**ITEMS RECEIVED AFTER THE PRODUCTION OF THE REPORT  
FOR THE PLANNING COMMITTEE  
TO BE HELD ON 27 SEPTEMBER, 2018**

COMMITTEE DATE : 27 September 2018

<b>Application No.:</b> 2018/00655/FUL	<b>Case Officer:</b> Miss Angharad Hobbs
<b>Location:</b> 1, Lombard Buildings, Lombard Street, Barry	
<b>Proposal:</b> Change of use from A1 to D1 to a childrens nursery, providing day care for babies & children aged 0-12

<b>Application No.</b> 2018/00730/FUL	<b>Case Officer:</b> Mrs Y J Prichard
<b>Location:</b> 6, Salmons Wood, Graig Penllyn <b>Proposal:</b> New dwelling within rear garden of 6, Salmons Wood including access and parking

### For Clarity

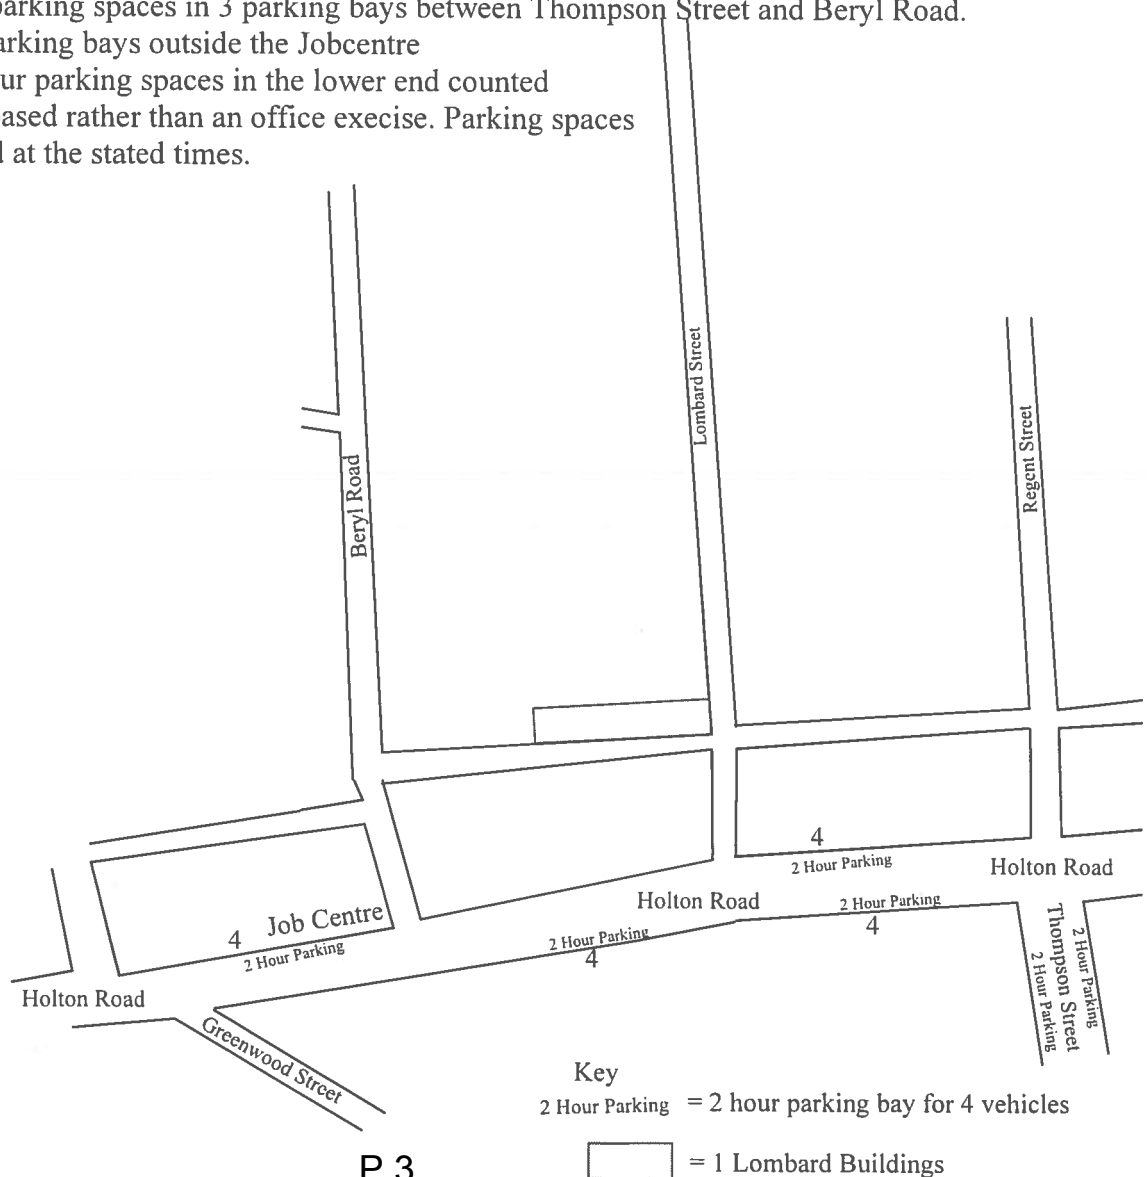
Parking mainly in Lombard Street with only 2 hour spaces counted  
Holton Road has 12 parking spaces in 3 parking bays between Thompson Street and Beryl Road.  
There are 4 normal parking bays outside the Jobcentre  
Beryl Road only 2 hour parking spaces in the lower end counted  
The survey was site based rather than an office exercise. Parking spaces were actually counted at the stated times.

**Officer Response:** The parking analysis corroborates the findings of the previous parking analysis which was carried out during the school holidays. Whilst the time slots are slightly different to those previously reported, there are only three instances where parking reported during term time was below that of the school holidays and these are as follows:

In every other instance, the level of parking available during term time was either identical or higher than that provided during the school holidays. It is therefore considered that there is sufficient parking to meet the demands of the proposed use.
